# UNITED STATES PATENT AND TRADEMARK OFFICE

APPLICATION NO.	FILING DATE	FIRST NAMED INVENTOR	ATTORNEY DOCKET NO.	CONFIRMATION NO.
09/738,755	12/15/2000	Anthony Reid	12153RRUS01U	2083

## Office Action Summary

### FINAL OFFICE ACTION

**FIG. 8**

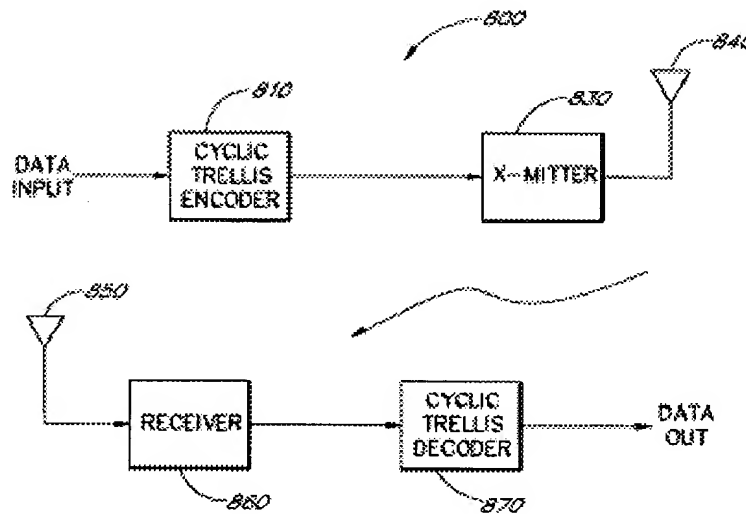
As per Claims 20, 22, Alamouti anticipates the claimed invention because Fig. 8 depicts a wireless system for providing data transfer over a wireless air link in networks such as GPRS/EDGE networks comprising trellis encoder/decoder (numerals 810 & 870) and wireless transmitter (numeral 830) that mitigates fading within transmission channels (Figs. 11-13 and 17-18) via QAM (Figs. 1A-B) with means to digitize data into radio waves via antenna (numeral 840), wherein channel fading due to said wireless air link is substantially reduced: Alamouti discloses channel fading reduction means, in col. 3 line 64, via maximizing minimum Euclidean distance between points of the signal constellation, *e.g.*, "... invention provides for a trellis encoder

*which trellis encodes input data signals, wherein the input data signals are mapped according to a modulation scheme such that a signal constellation defined by the modulation scheme cannot be set partitioned such that each level of set partitioning results in a substantially increased minimum Euclidean distance between points of the signal constellation.”*

**FIG. 8**

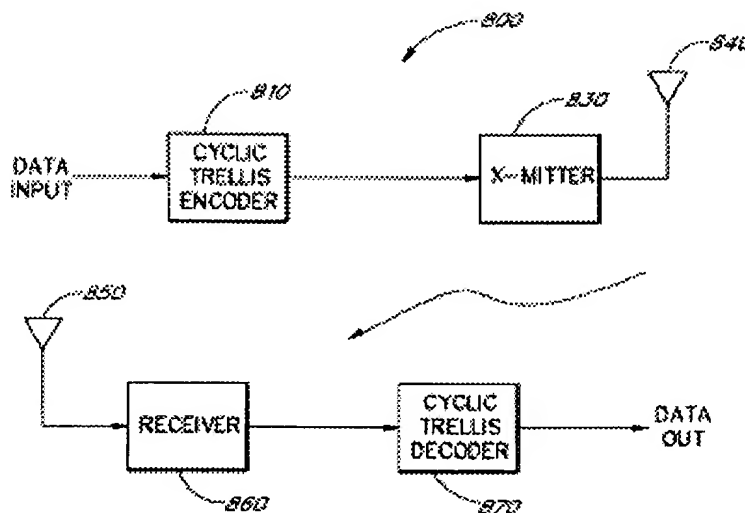
As per **Claims 1, 9-10, 12**, **Alamouti** substantially depicts wireless data transfer means over wireless channel of a GPRS/EDGE communication network, in Fig. 8 (below), comprising:

trellis coder (numeral 810) within a radio communication system or transceiver or terminal or device between an input/origination point for data being transmitted and interleaving mechanism

(col. 13 line 37) within a data transmission channel wherein said trellis coder specifically encodes said data to substantially eliminate fading on the transmission channel and increase capacity on an allocated bandwidth by providing a maximum Euclidian distance between words of said data during encoding, which distance reduces signal power required for transmitting said data over a wireless channel (**Alamouti** discloses such means, in col. 3 line 64, to maximize minimum Euclidean distance between points of the signal constellation, *e.g.*, “... *invention provides for a **trellis encoder** which trellis encodes input data signals, wherein the input data signals are mapped according to a **modulation** scheme such that a signal **constellation** defined by the modulation scheme cannot be set partitioned such that each level of set partitioning results in a **substantially increased minimum Euclidean distance** between points of the signal constellation.*”); and wireless transmitter (numeral 830) that mitigates channel fading (channel fading comprising AWGN and Rician or Rayleigh fading similar to applicants’ channel fading characteristics as formulated in applicants’ specification on page 13 line 4 et seq.: **Alamouti** discloses such data protection means, in col. 14 line 6 et seq., and Figs. 11-13 and 17-18) via QAM (Figs. 1A-B) with means to digitize data into radio waves via antenna (numeral 840).

**Not specifically described** in detail in **Alamouti** is the step whereby the act of computing Euclidian distance includes optimizing such distance for substantial reduction of signal power required for transmitting said data over a wireless channel.

FIG. 8

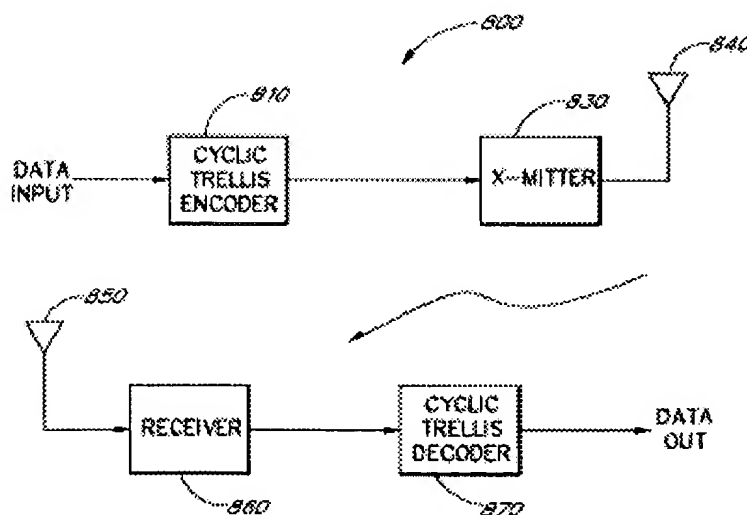
As per Claims 15, 18, **Alamouti** substantially depicts wireless data transfer means over wireless channel of a communication network, in Fig. 8, comprising, trellis encoding/decoding means (numerals 810 & 870) within a radio communication system or transceiver or terminal or device

means (numeral 860) for receiving data for transmission over a wireless link of a wireless network; evaluating a maximum Euclidian distance (**Alamouti** discloses such means, in col. 3 line 64, to maximize minimum Euclidean distance between points of the signal constellation,

e.g., "... invention provides for a **trellis encoder** which trellis encodes input data signals, wherein the input data signals are mapped according to a **modulation** scheme such that a signal **constellation** defined by the modulation scheme cannot be set partitioned such that each level of set partitioning results in a **substantially increased minimum Euclidean distance** between points of the signal constellation.") between codewords of said data to reduce signal power requirements; minimizing fading channel effects in col. 3 line 64 with transmission of said codewords; encoding said data utilizing results of said evaluating and minimizing steps in Fig. 8 via trellis encoding/decoding means (numerals 810 & 870) within a radio communication system or transceiver or terminal or device; and transmitting (col. 13 line 37) said encoded data over said wireless link. (**Alamouti** discloses such means, in col. 3 line 64, to maximize minimum Euclidean distance between points of the signal constellation, e.g., "... invention provides for a **trellis encoder** which trellis encodes input data signals, wherein the input data signals are mapped according to a **modulation** scheme such that a signal **constellation** defined by the modulation scheme cannot be set partitioned such that each level of set partitioning results in a **substantially increased minimum Euclidean distance** between points of the signal constellation."); and wireless transmitter (numeral 830) that mitigates channel fading (channel fading comprising AWGN and Rician or Rayleigh fading similar to applicants' channel fading characteristics as formulated in applicants' specification on page 13 line 4 et seq.: **Alamouti** discloses such data protection means, in col. 14 line 6 et seq., and Figs. 11-13 and 17-18) via QAM (Figs. 1A-B) with means to digitize data into radio waves via antenna (numeral 840). **Alamouti** further discloses TCM via software means in col. 22 line 16.
